**Purpose:** To request that the Independent Planning Commission review the Gateway determination taking into account information provided by the proponent and provide advice regarding the merit of the review request.

| <b>Dept. ref. no</b>          | GR_2020_CBANK_001_00 (PP_2016_CBANK_001_01)  |   |
| <b>Address/ location</b>      | 30 – 46 Auburn Road, Regents Park<br>(Lot 1 DP 656032 & Lot 2 DP 433938)           |   |
| <b>Proposal</b>               | To increase the maximum building height and floor space ratio controls at the site |   |

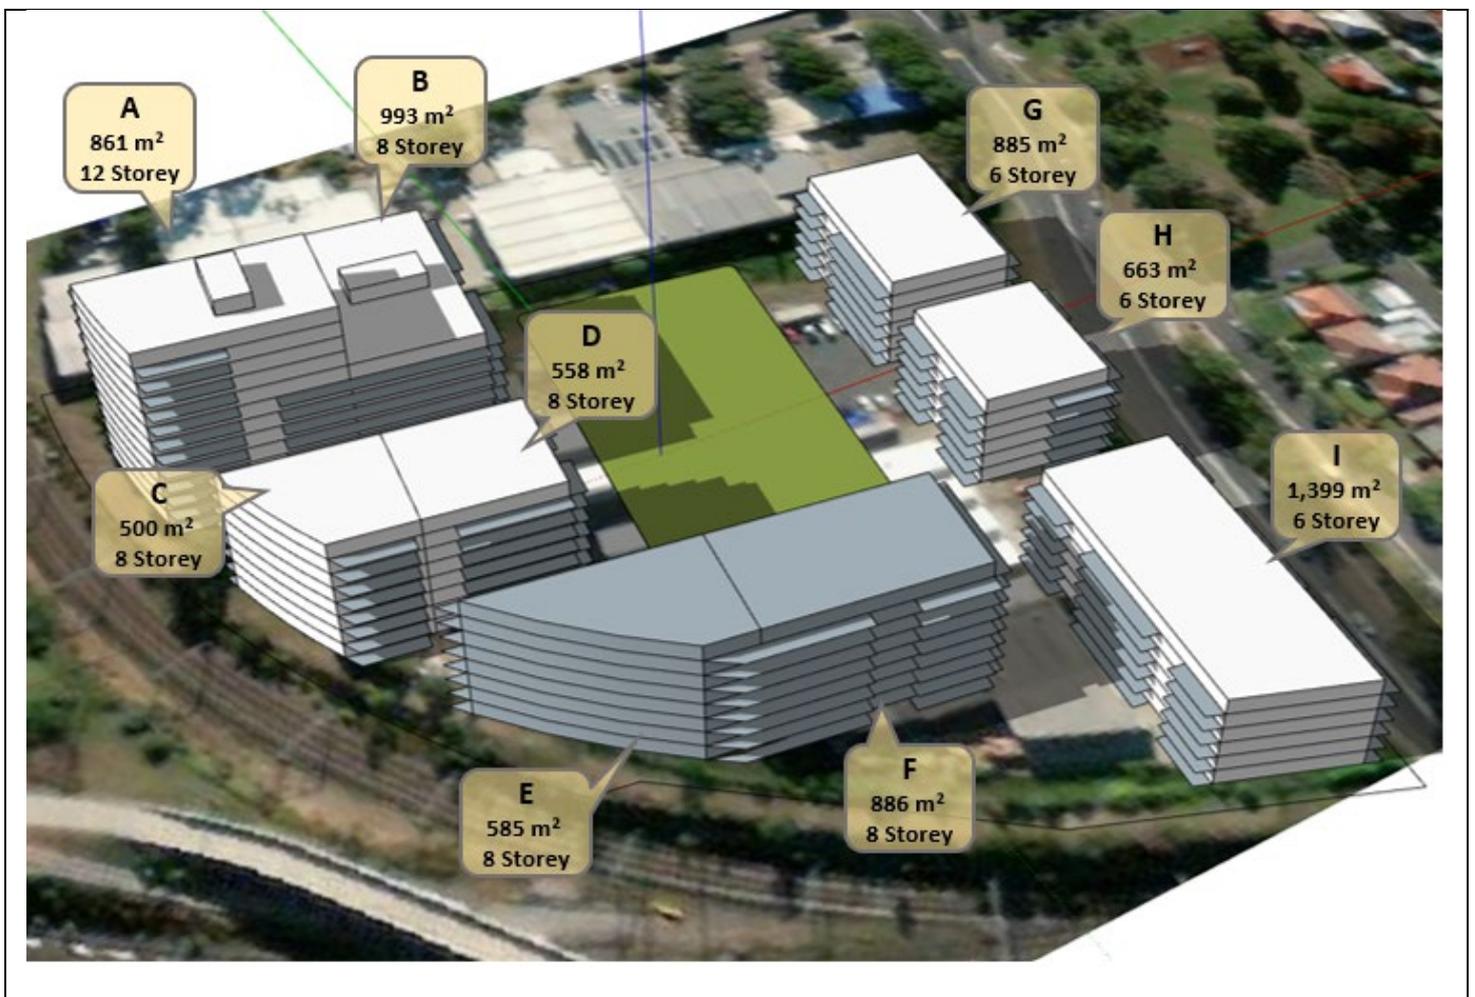
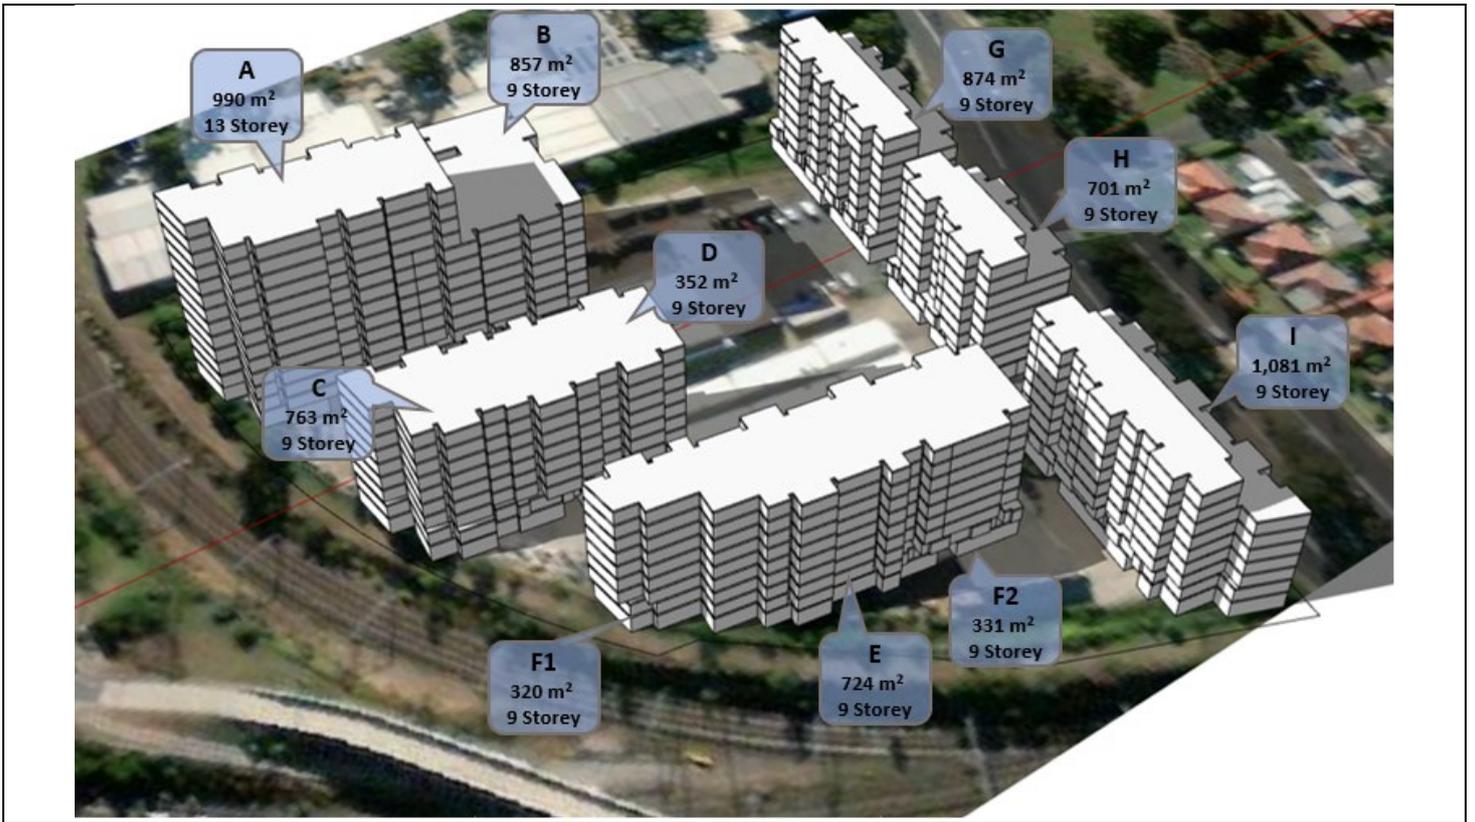
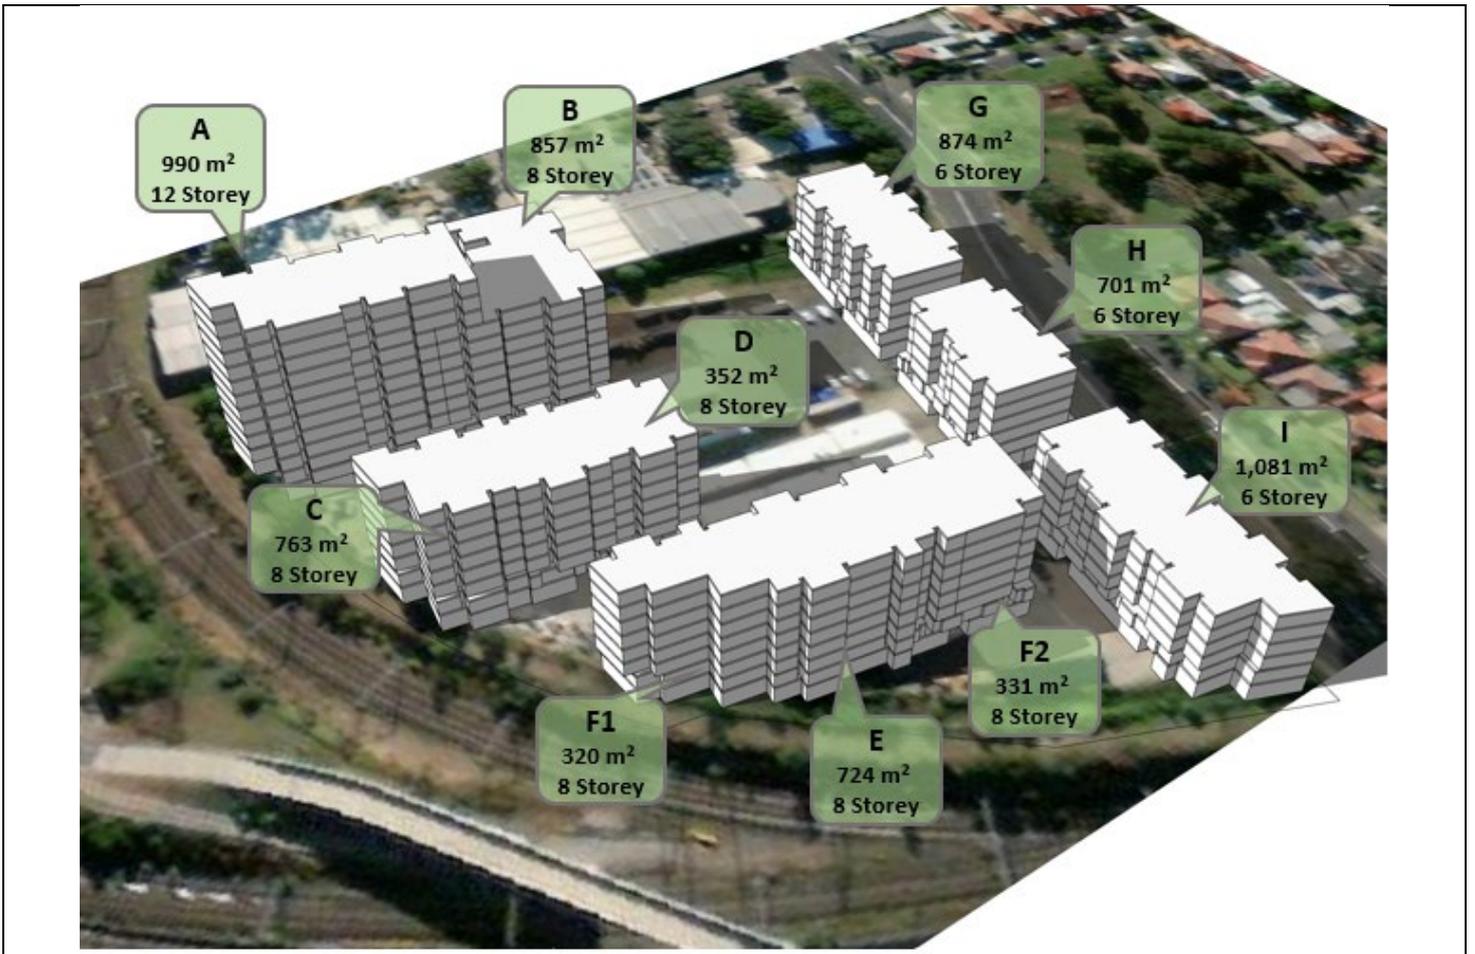
| <p><b>January 2020</b></p> | <p>Considering the ongoing contentions regarding alternative / incorrect calculations and efficiency rates being applied across the various schemes, the Department's Urban Design Team undertook a peer review of the scheme and calculations by McGregor Coxall.</p> <p>Utilising correct land survey data provided by the proponent, the Urban Design Team tested:</p> <ul style="list-style-type: none"> <li>the McGregor Coxall January 2019 scheme (i.e. 6, 8 and 12 storeys) (<b>Figure 6</b>)</li> <li>the proponent's proposed scheme (ie.7, 8 and 9 storeys) (<b>Figure 7</b>)</li> </ul> |

- the proponent's proposed scheme but utilising the heights supported under the McGregor Coxall scheme (i.e. 6, 8 and 12 storeys) (**Figure 8**).

While minor variations to McGregor Coxall's calculations were identified, the Urban Design Team determined that when applying a 75% efficiency to the GBA under McGregor Coxall's original scheme (**Figure 6**) and the proponent's scheme when utilising the heights supported under McGregor Coxall scheme (**Figure 8**), the FSR was 2:1 (or less) (**Table 1**).

Further to this, the Urban Design Team indicated that this FSR would enable a proposal of reduced bulk and scale and provide better design flexibility to achieve ADG criteria and better urban design outcomes.

The Department concluded that maximum building heights should be specified under the Gateway determination utilising standards under the LEP. These heights facilitated the McGregor Coxall scheme and ensured the number of storeys permitted at the site did not increase (i.e. above 6, 8 and 12 storeys).

Figure 9 – The Proponent's Proposed Studio MRA Scheme with Council's proposed setbacks (Image prepared by DPIE)

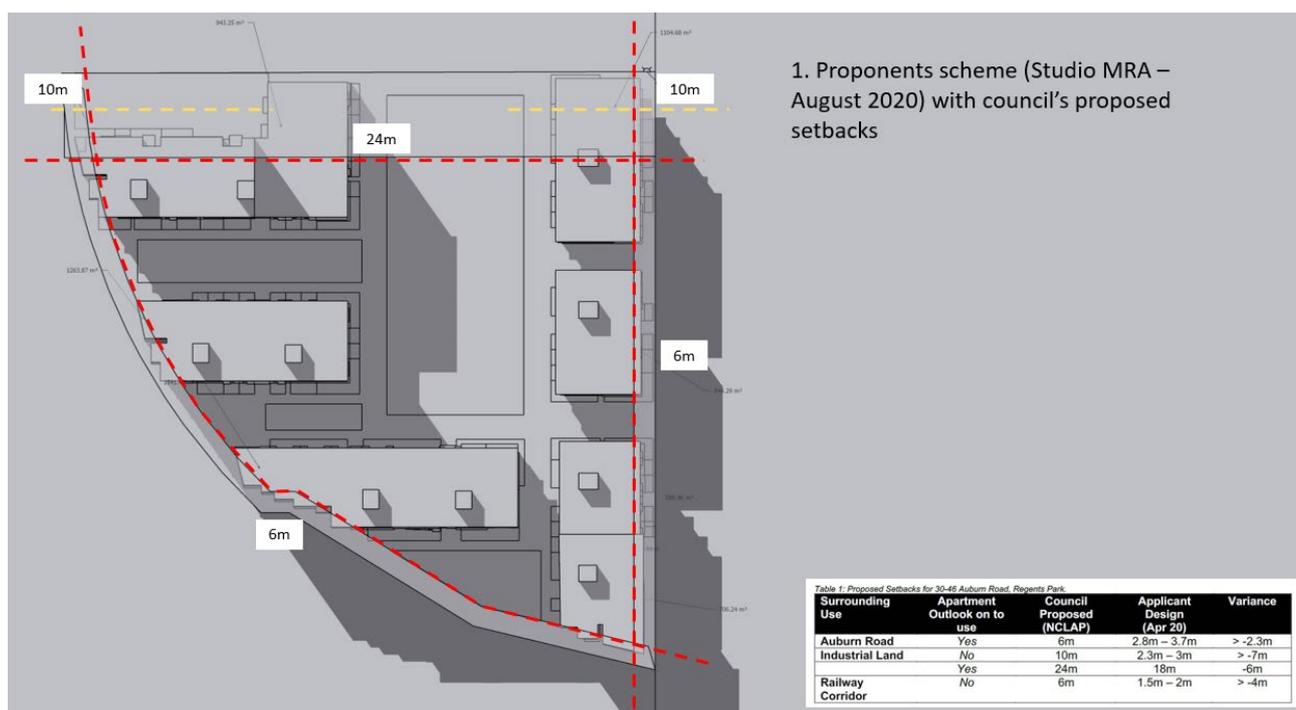
The Department's Urban Design Team further tested the proponent's scheme against the setbacks proposed by Council.

The proponent's scheme encroaches into the setbacks proposed by Council for inclusion in a future site-specific DCP (**Figure 9**).

The Department's Urban Design team considered the impacts of responding to Council's recommended setbacks, together with adequate solar access and retention of green open space, and found that these parameters delivered an FSR of 1.9:1

Figure 11 - Proponent's Proposed Scheme (April 2020) showing various building height standards

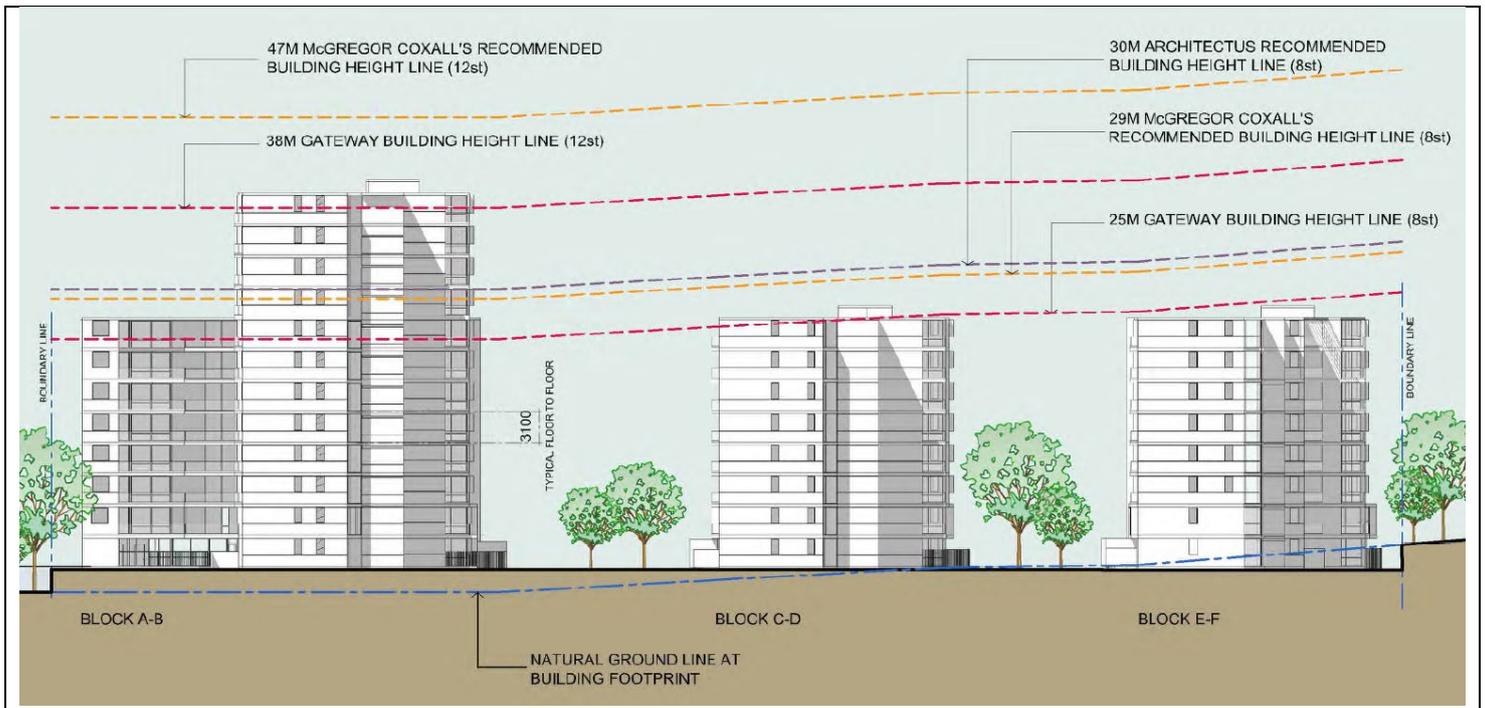
The proponent's various iterations of proposed heights are not supported. The Department considers that supporting height in metres proposed by the proponent, is inconsistent with the ADG and could allow for additional storeys being accommodated on the site above what has been supported through this planning proposal process.

The height section below provided by the proponent under its updated Design Review Report (**Figure 11**) clearly indicates that the appropriate number of storeys i.e. 6, 8 and 12 storeys can be achieved within a building height limit of 23m, 29m and 41m under the proponent's scheme. On this basis, the Department supports an amendment to the Gateway determination, to reflect maximum building heights calculated in accordance with the ADG.

The Department considers that amending the Gateway determination to align the maximum building heights with the ADG formula is reasonable to ensure the number of storeys identified under the McGregor Coxall scheme can be achieved. It is also noted that these measurements are similar to those recommended under Council's submission to this Gateway Review (**Attachment H**).
